Stellaris[®] LM3S3826 RevB1 Errata

This document contains known errata at the time of publication for the Stellaris[®] LM3S3826 microcontroller. The table below summarizes the errata and lists the affected revisions. See the data sheet for more details.

Figure 1. Workaround Circuit to Ensure Initial Power Up

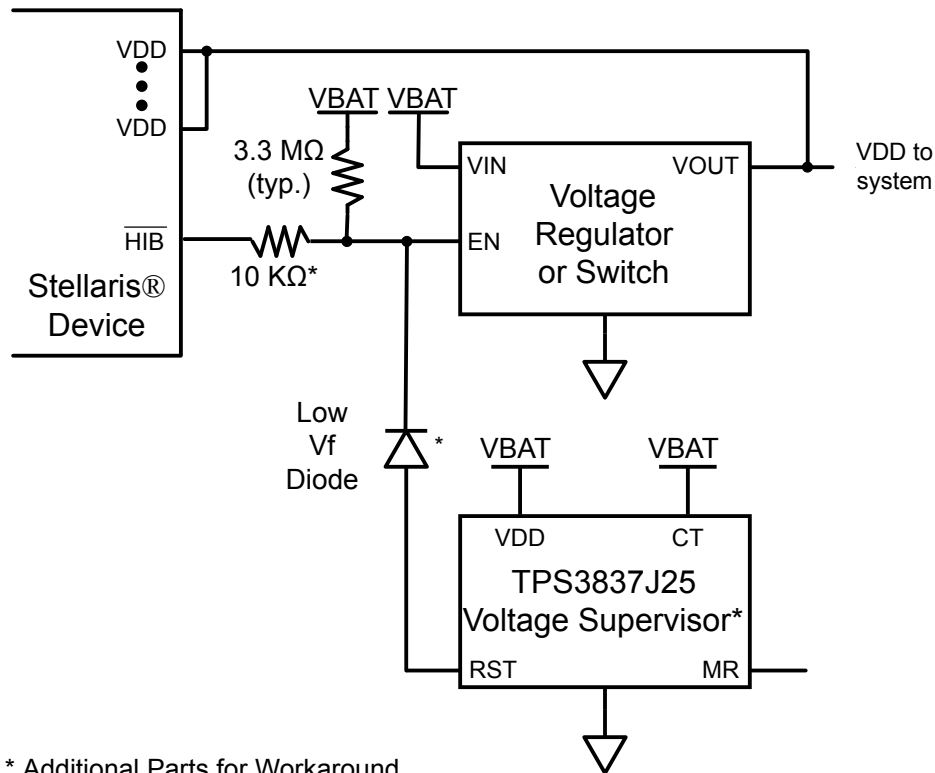
If V_{DD} is not powered when voltage is first applied to V_{BAT} , the state of the Hibernation module is indeterminate and the \overline{HIB} signal may be asserted. In this indeterminate state, a lock condition can occur in which the Hibernation module waits for a power-on-reset, but that reset cannot occur until the module deasserts \overline{HIB} . This issue is related to the errata "Hibernation module may have higher current draw than specified in data sheet under certain conditions" on page 5.

The workaround implementation depends on the system-level power supply configuration. For systems that use a battery as the primary power source, an external voltage supervisor (TPS383J25DBV or similar) circuit can be added to force the V_{DD} power supply to start when the battery voltage is first applied (see Figure 1). The voltage supervisor requires only 220 nA and generates a 200-ms positive pulse to turn on the V_{DD} regulator and activate the microcontroller's internal POR circuit.

Figure 2. Configuration of External Regulator

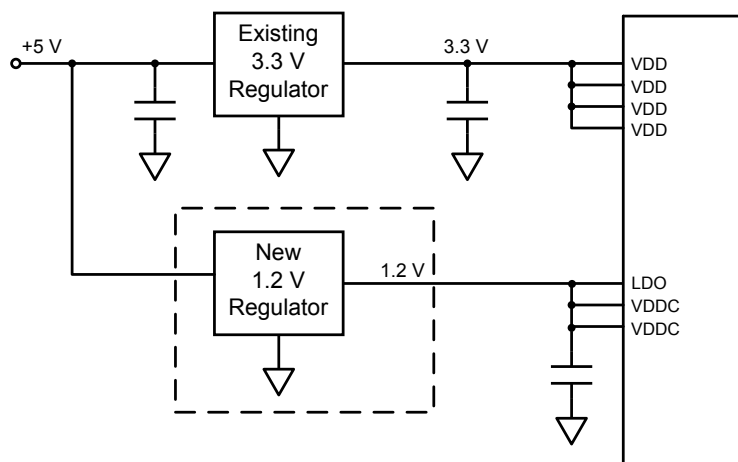
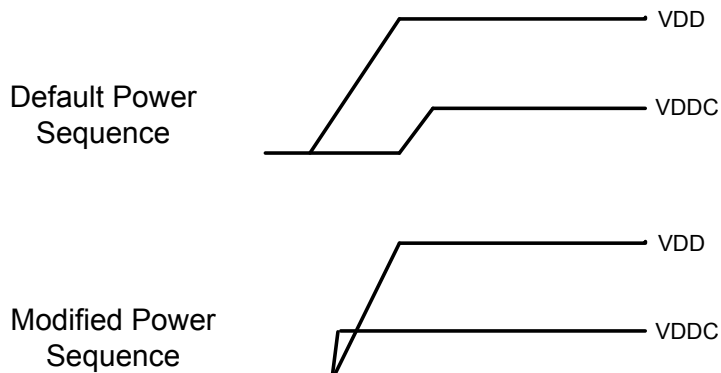
Incorrect power sequencing during power up can disrupt operation and potentially cause device failure.

V_{DDC} must be applied approximately 50 μ s before V_{DD} . Normally V_{DDC} is controlled by the part's internal LDO voltage regulator. The workaround requires the addition of an external regulator (see Figure 2) to ensure that V_{DDC} sequencing requirements are met (see Figure 3). Recommended regulators include FAN1112SX (SOT223) and FAN2558S12X (SOT23-5).

This fix mitigates the on-chip power issue, but does not solve it completely. During development, the Flash memory should also be reprogrammed (using LMflash or another programming tool) at least once a week.
